Architect's Supplemental Instructions

Architect's ASI No: 045

Project:
Webster University
Interdisciplinary Science
Building

Date Issued: 01/20/2017

PIPE FREEZE PROTECTION DETAIL

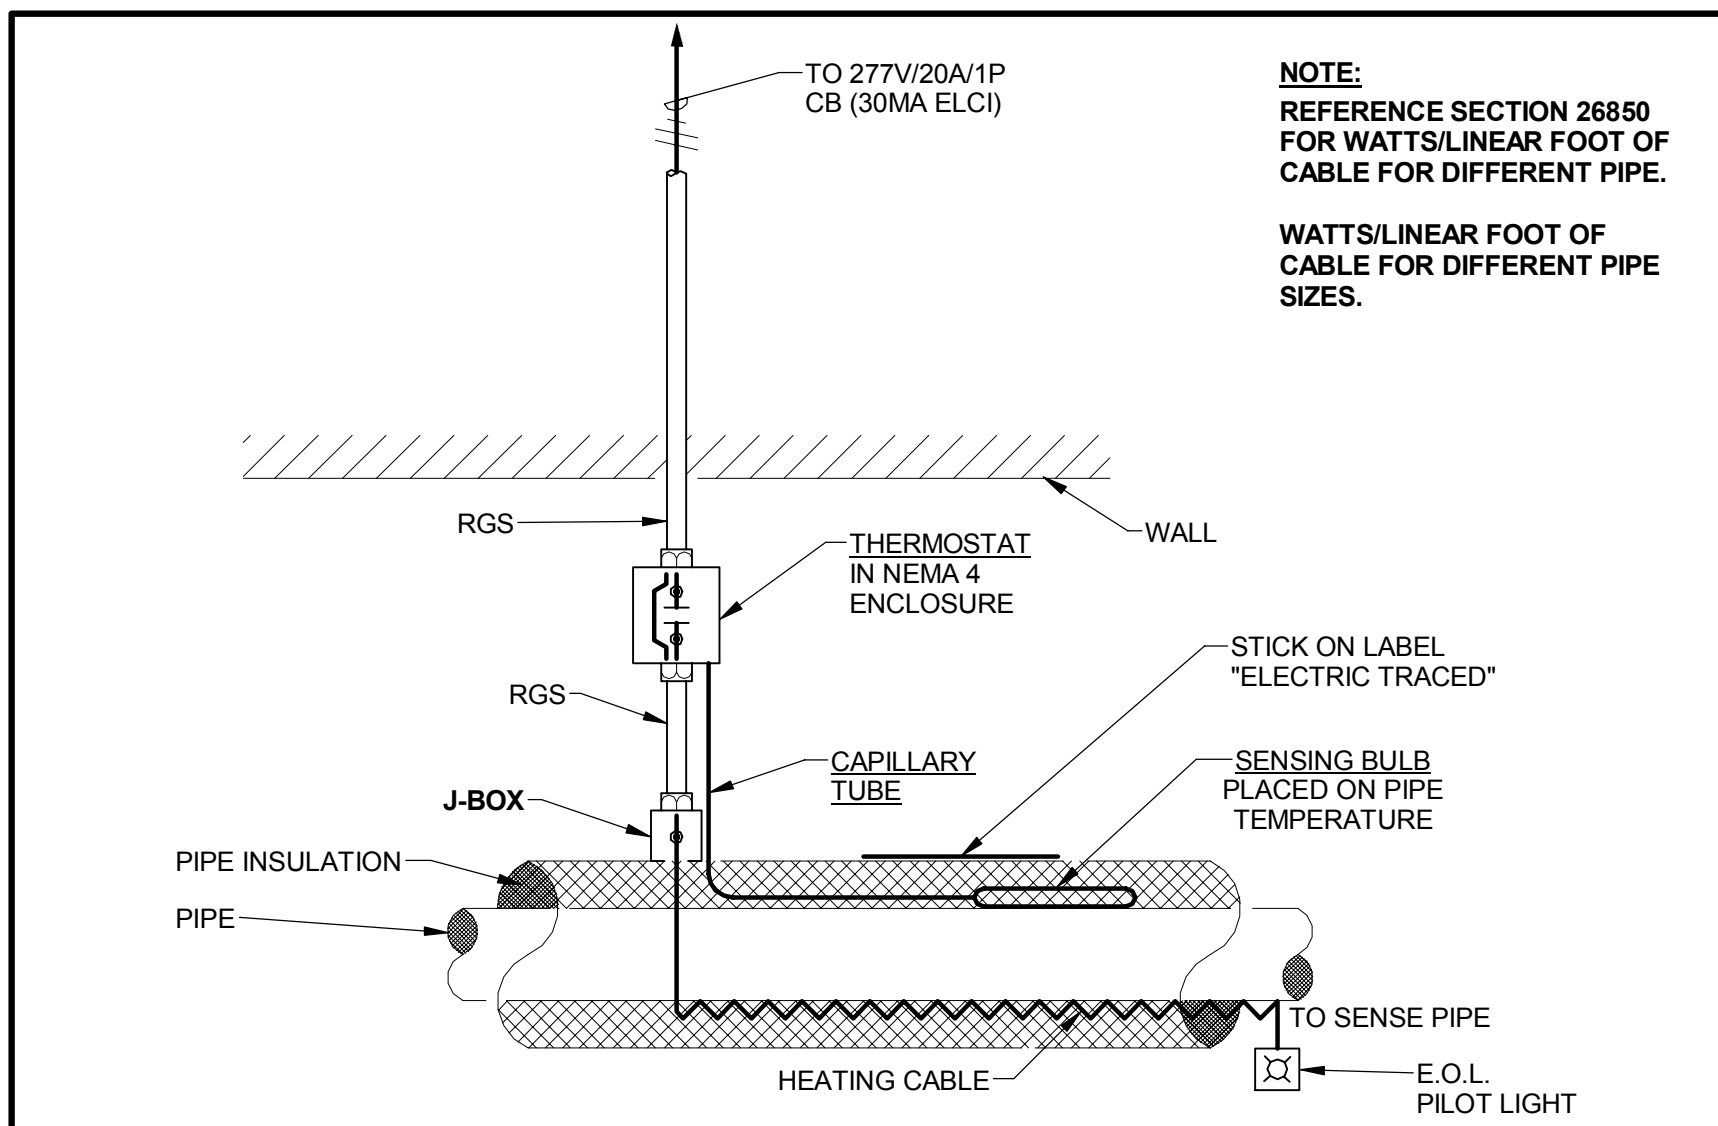
- Add pipe freeze protection detail.
